EXTINGUISH THE TORCH MEETING

Project: Lake County Resurface and Roadside Improvements MP 287.8 to MP 297.9

LESSONS LEARNED

SUMMARY REPORT

4) Legends for Identifying Work:

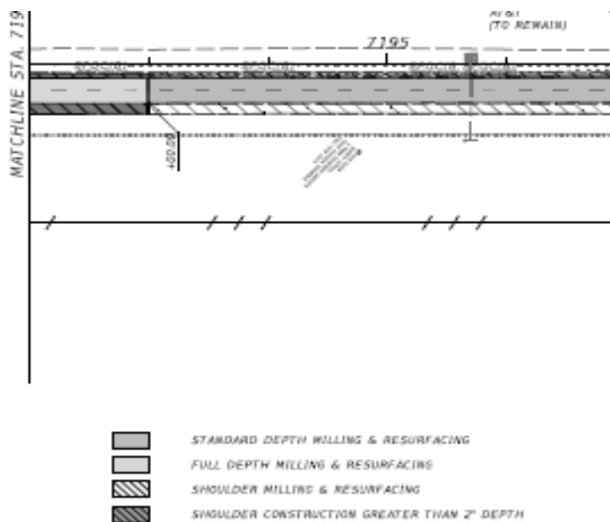
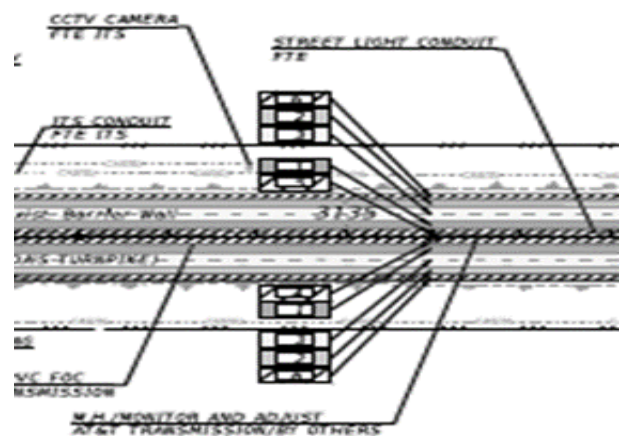
ISSUE SUMMARY: The designer created a Legend to identify differences in milling and resurfacing depths. The Legend identified mainline milling as “Standard” or “Full Depth”, but with 21 milling depths provided in the Plans the Legend led to confusion. This confusion was compounded as the allowable the lane closure times varied based on milling depths.

RESOLUTION: Contractor and CEI worked together to assure work matched the Stationing in the Plans.

LESSON LEARNED: In future Plans, where there are multiple thicknesses for milling and resurfacing, use additional numbering system to depict depths. At least in the Legend, state the range of thicknesses for area being represented. In another project, a box was utilized with a number representing depth and then a leader was shown to the area it represented.

5) Temporary Asphalt / Rumble Strips:

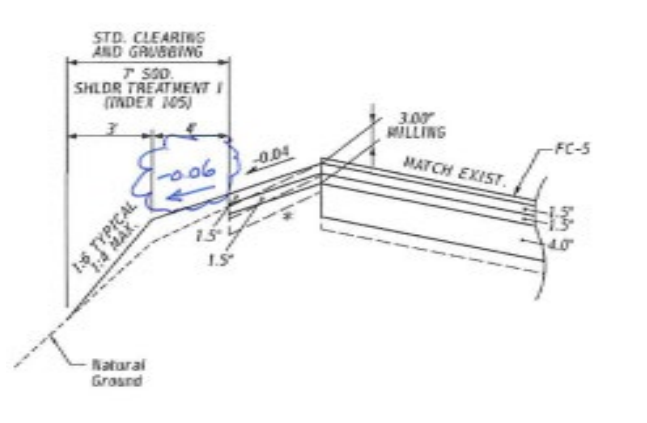
ISSUE SUMMARY: The Contractor submitted an RFI for how covering Rumble Strips would be paid and what satisfies the requirement for covering of the rumble strips. Our initial response that it should be included in the Lump Sum MOT. However, the Estimates Bulletin 14-06 and the most recent Basis of Estimates prohibits temporary asphalt to be paid under Lump Sum MOT and requires the payment through a Special Detour.

RESOLUTION: It was fairly clear that the Contractor did not have enough in the contract under Lump Sum MOT to cover this cost. The cost of covering the rumble strips was handled in a Lump Sum Supplemental Agreement.

LESSON LEARNED: Specify the cost of the of filling in the Rumble Strips under 102-2 Special Detour (Lump Sum). The plans should not quantify temporary asphalt tonnage; however, the Plans need to provide width, length, and thickness information so that the Contractor knows the work required by this Special Detour.
